Markup of Existing Technical Specifications Bases

T.S. Bases 3.3 & 3.5

Oconee Nuclear Station
Figure 3.5.2-16a

Oconee Nuclear Station
Figure 3.5.2-16c

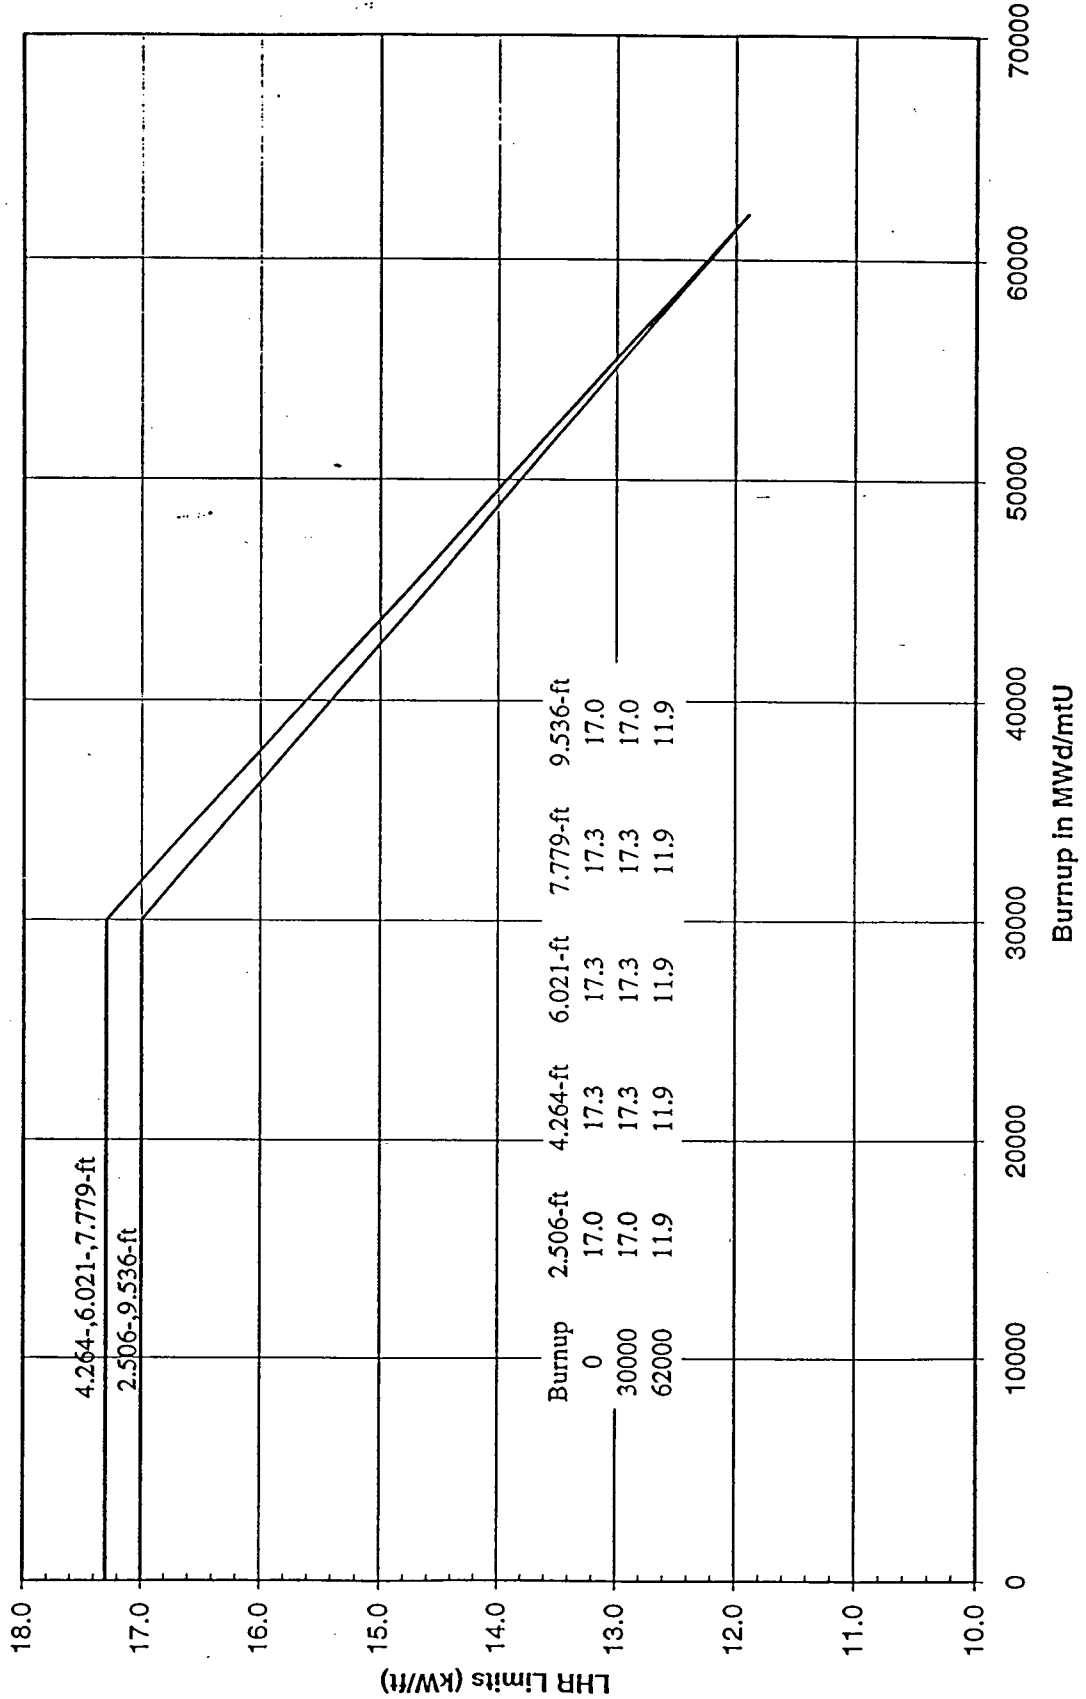
delete

LOCA-Limited Maximum Allowable Linear Heat Rate For Mark-B10* Fuel Rods

* Mark-B10 fuel rods with a fuel pellet diameter of 0.3735 inches are used in the Mark B10T fuel assemblies.

LOCA LHR Limits for Mk-B10 Fuel

LOCA LHR Limits for Mk-11 LTA Fuel

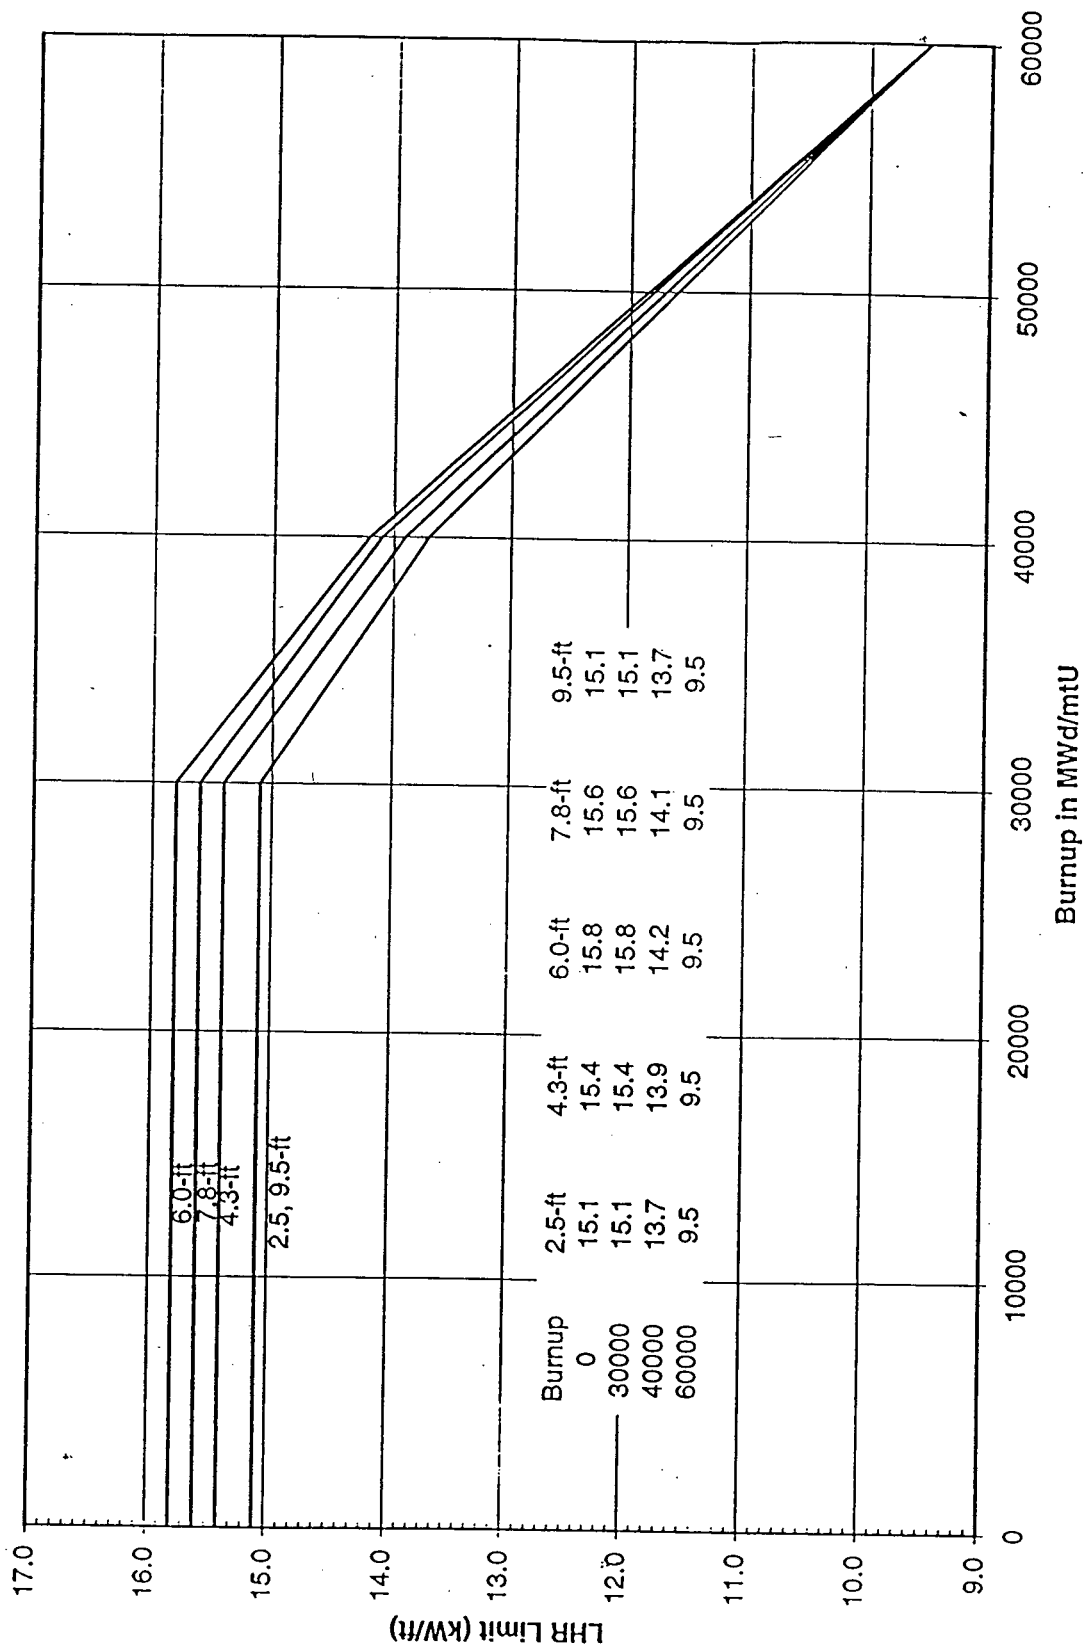
The power-imbalance envelope obtained in accordance with the approved methodology is based on LOCA analyses ^{and d} which have defined the maximum linear heat rate (see Figures 3.5.2-16a, b, and c) such that the maximum clad temperature will not exceed the Final Acceptance Criteria. Corrective measures will be taken immediately should the indicated quadrant tilt, rod position, or imbalance be outside their specified boundary. Operation in a situation that would cause the Final Acceptance Criteria to be approached should a LOCA occur is highly improbable because all of the power distribution parameters (quadrant tilt, rod position, and imbalance) must be at their limits while simultaneously all other engineering and uncertainty factors are also at their limits.** Conservatism is introduced by application of:

The power-imbalance envelope obtained in accordance with the approved methodology is based on LOCA analyses which have defined the maximum linear heat rate (see Figure 3.5.2-16a, b, c, and d) such that the maximum clad temperature will not exceed the Final Acceptance Criteria. Corrective measures will be taken immediately should the indicated quadrant tilt, rod position, or imbalance be outside their specified boundary. Operation in a situation that would cause the Final Acceptance Criteria to be approached should a LOCA occur is highly improbable because all of the power distribution parameters (quadrant tilt, rod position, and imbalance) must be at their limits while simultaneously all other engineering and uncertainty factors are also at their limits.** Conservatism is introduced by application of:

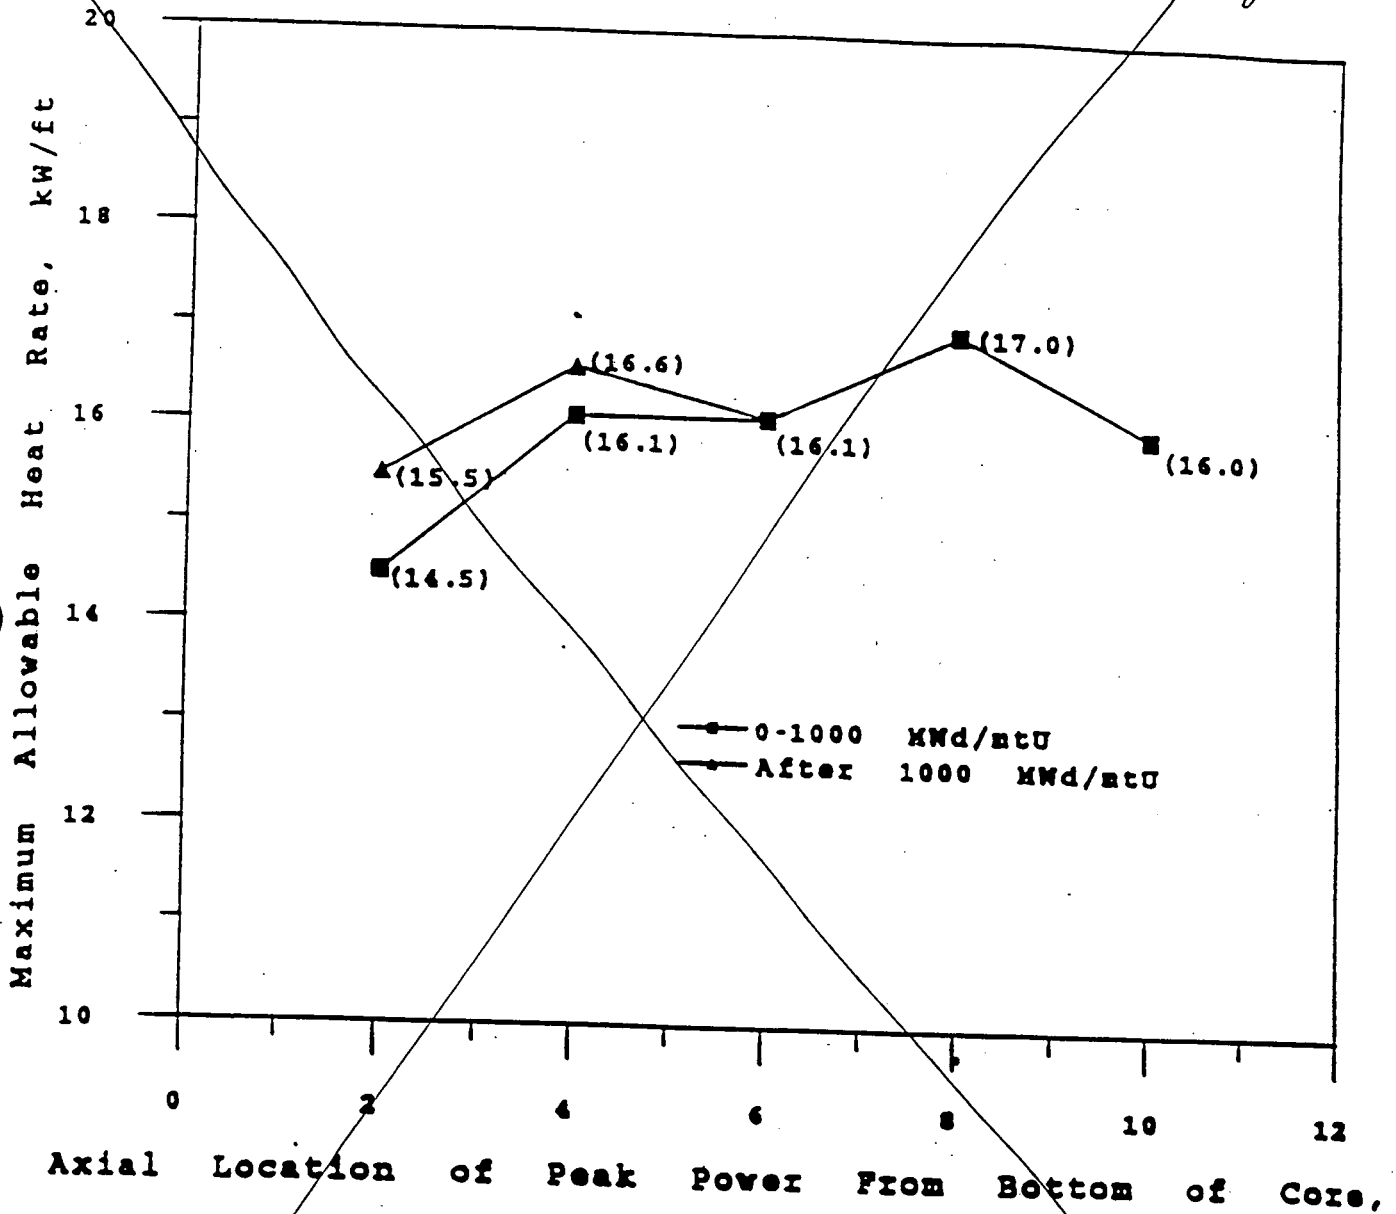
delete

* Mark-B8 fuel rods with a fuel pellet diameter of 0.3686 inches are used in Mark-B8 and earlier fuel assemblies.

LIST OF FIGURES

Oconee Nuclear Station
Figure 3.5.2-16b

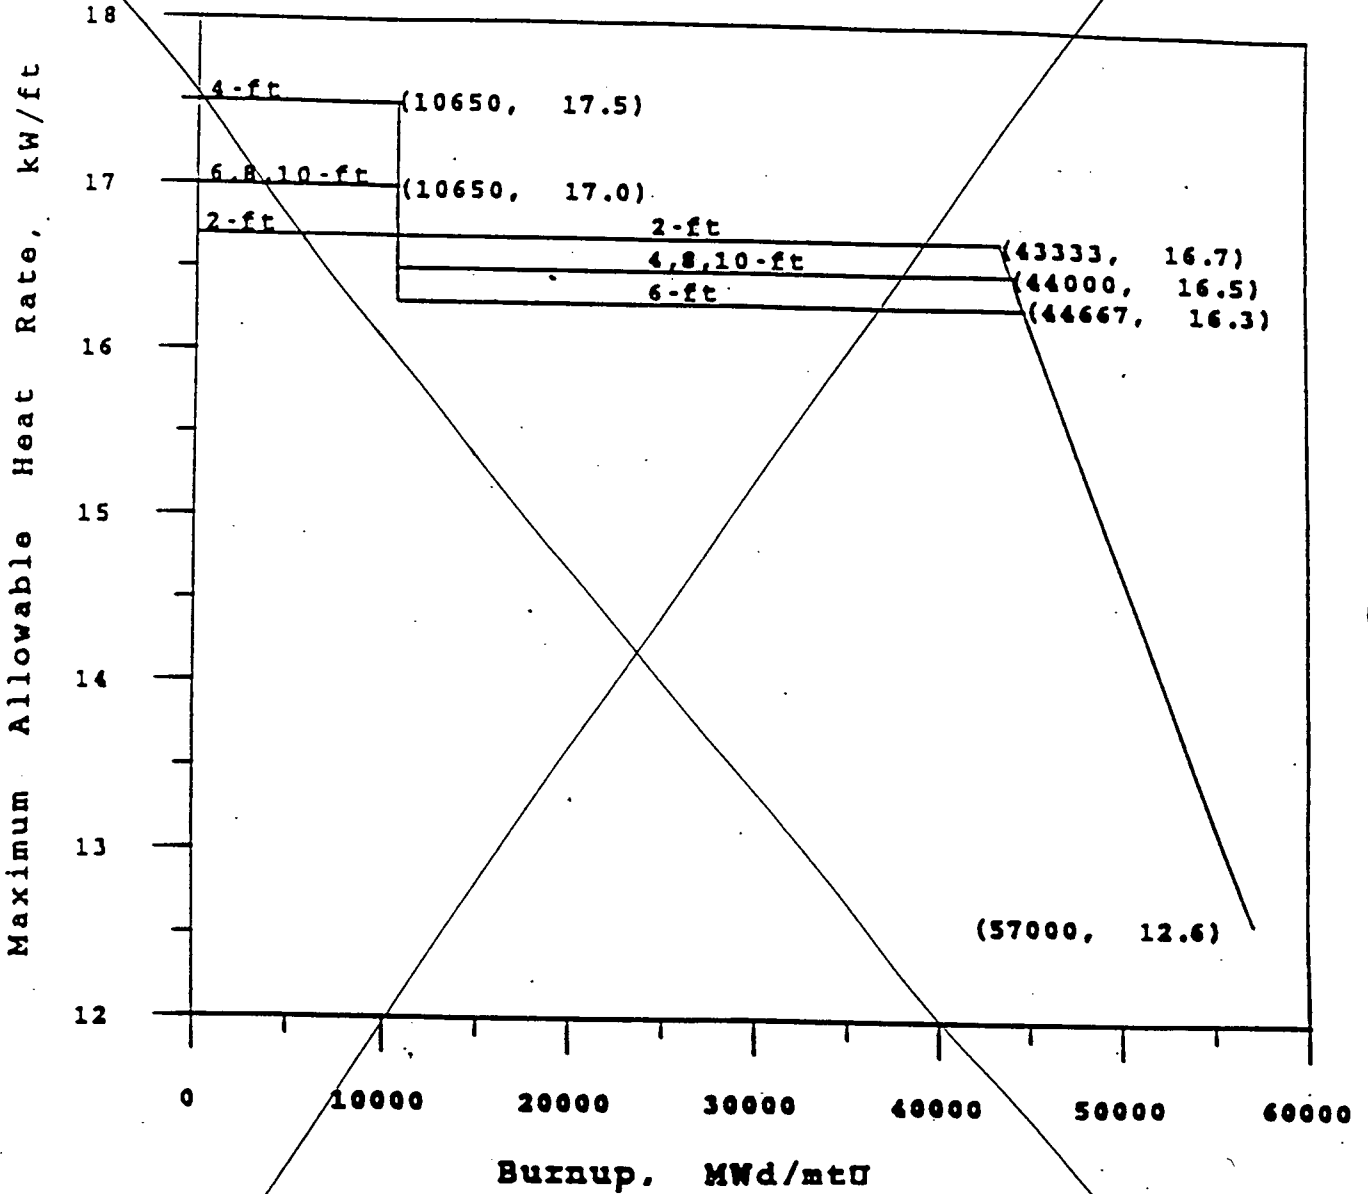
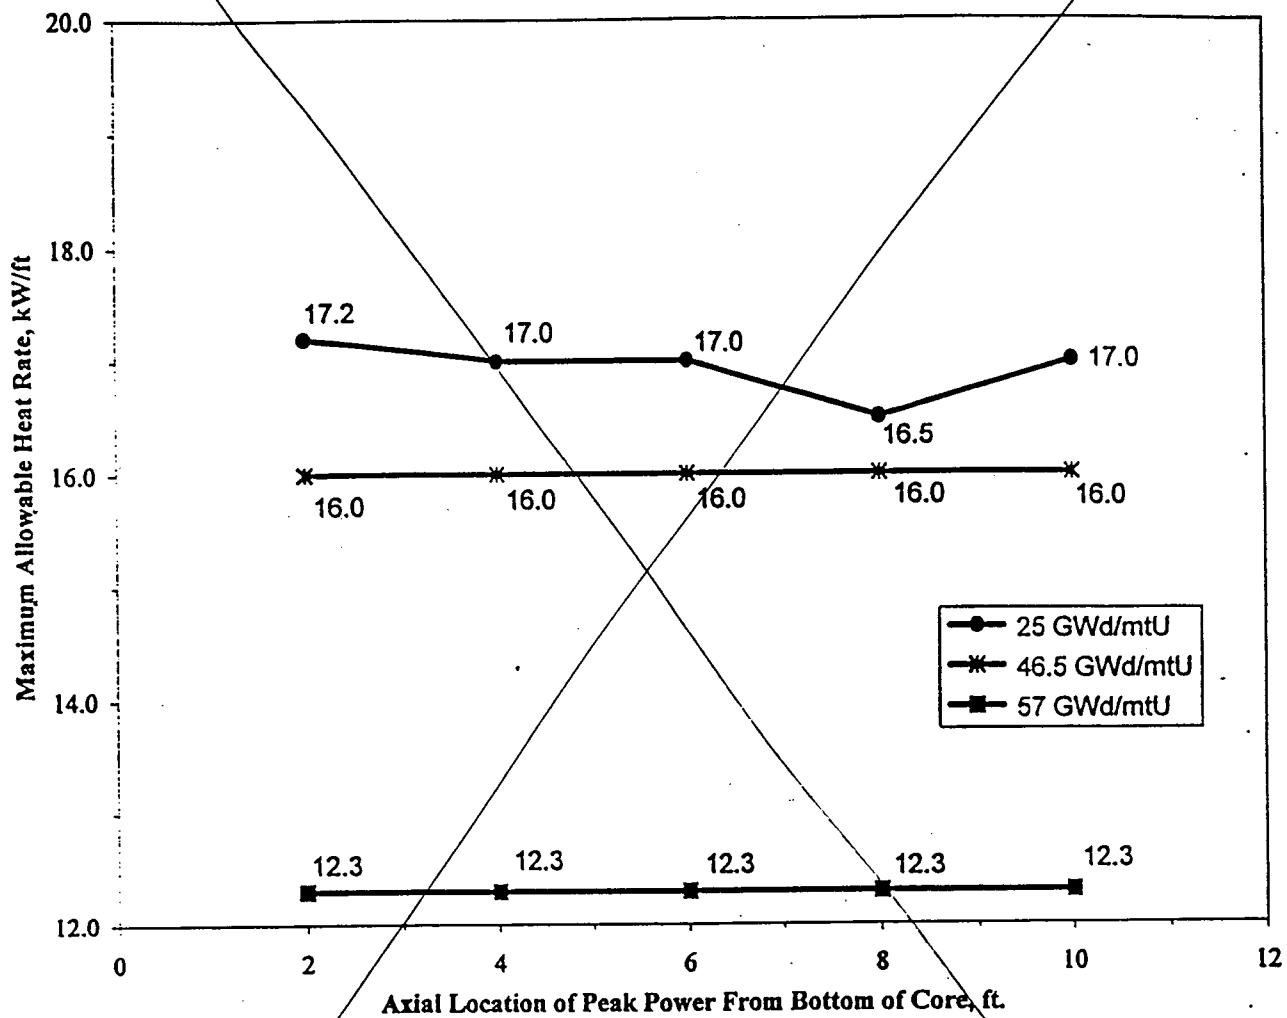
delete

*Mark-B9 fuel rods with a fuel pellet diameter of 0.3700 inches are used in Mark-B9 and Mark-B10 fuel assemblies.

<u>Figure</u>		<u>Page</u>
3.1.2-1A	Reactor Coolant System Normal Operation Heatup Limitations - Unit 1	3.1-6
3.1.2-1B	Reactor Coolant System Normal Operation Heatup Limitations - Unit 2	3.1-6a
